# UNITED STATES PATENT AND TRADEMARK OFFICE

APPLICATION NO.	FILING DATE	FIRST NAMED INVENTOR	ATTORNEY DOCKET NO.	CONFIRMATION NO.
10/796,628	03/08/2004	Han Cheol Ryu	2013P157	2826
8791	7590	04/28/2006	EXAMINER	
BLAKELY SOKOLOFF TAYLOR & ZAFMAN 12400 WILSHIRE BOULEVARD SEVENTH FLOOR LOS ANGELES, CA 90025-1030			OLSEN, ALLAN W	
			ART UNIT	PAPER NUMBER
			1763

<b>Office Action Summary</b>	<b>Application No.</b> 10/796,628	<b>Applicant(s)</b> RYU ET AL.	
	<b>Examiner</b> Allan Olsen	<b>Art Unit</b> 1763

FIG. 3E

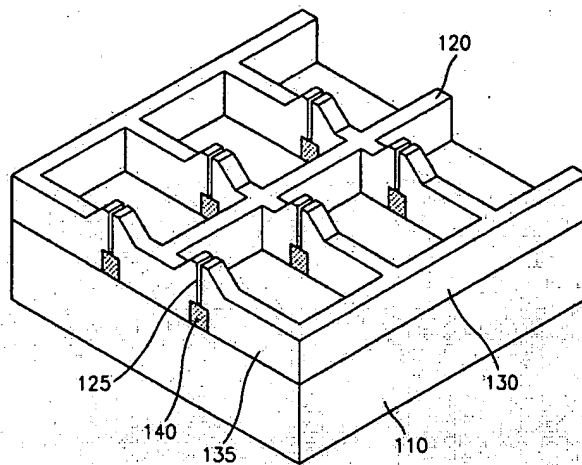
The drawings are objected to because in Figure 2 the first electrode 125 and the second electrode 135 that are shown as components of an IDC 150 are from two different IDC's, as such, the indicated grouping of components does not constitute an IDC. Also, as in the previous Office action, the drawings are objected to for failing to comply with 37 CFR 1.84(p)(4) because reference character "150" has been used to designate an IDC in figure 4C whereas in figure 4A "150" does not point to the IDC of Figure 4C. The depiction of IDC 150 in figure 4C is close-up of figure 4B, which is a close-up of figure 4A. In Figure 4A, the reference number 150 points to a region that is outside the region that is detailed in figure 4B. Below is applicant's figure 3E to which the examiner has added the reference character 150 - twice - one reflecting the representation of figure 4A and the other reflecting 4C.

Corrected drawing sheets in compliance with 37 CFR 1.121(d) are required in reply to the Office action to avoid abandonment of the application. Any amended replacement drawing sheet should include all of the figures appearing on the immediate prior version of the sheet, even if only one figure is being amended. The figure or figure number of an amended drawing should not be labeled as "amended." If a drawing figure is to be canceled, the appropriate figure must be removed from the replacement sheet, and where necessary, the remaining figures must be renumbered and appropriate changes made to the brief description of the several views of the drawings for consistency. Additional replacement sheets may be necessary to show the renumbering of the remaining figures. Each drawing sheet submitted after the filing date of an
